# PARTS & SERVICE NEWS

REF NO.	AT97102A
DATE	April 20, 2004

**SUBJECT:** IMPROVED COUPLING ON TORQUE CONVERTER AND TRANSMISSION

**PURPOSE:** To introduce an improved inner cap of the coupling for the torque converter and transmission

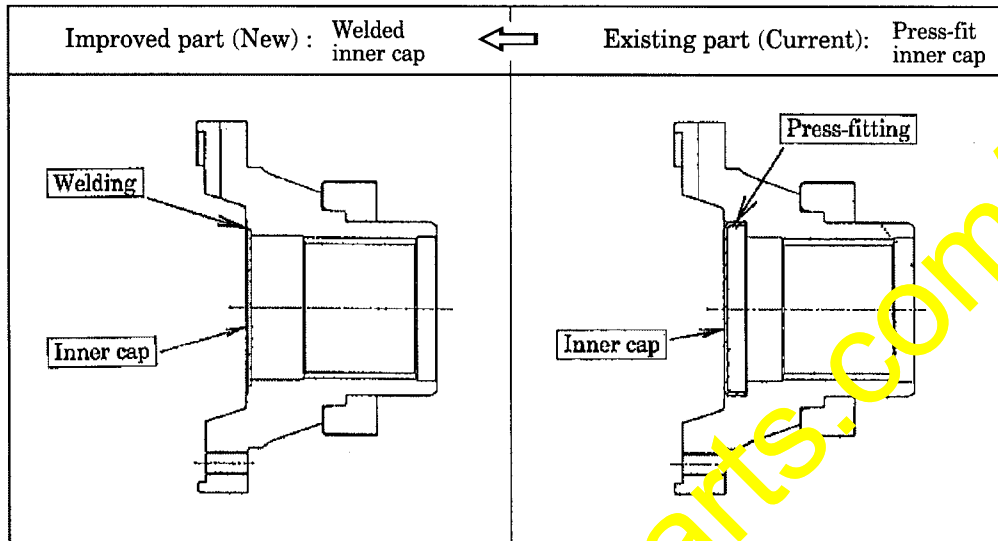
This **Parts & Service News** will introduce an improved inner cap of the coupling for the torque converter and transmission with increased resistance to prevent the inner cap slipping out from the coupling inside.

To increase resistance against slipping out of the inner cap, the installation method of the inner cap into the coupling has been changed from the current press-fitting method to welding method.

Replace the coupling referring to the Shop Manual
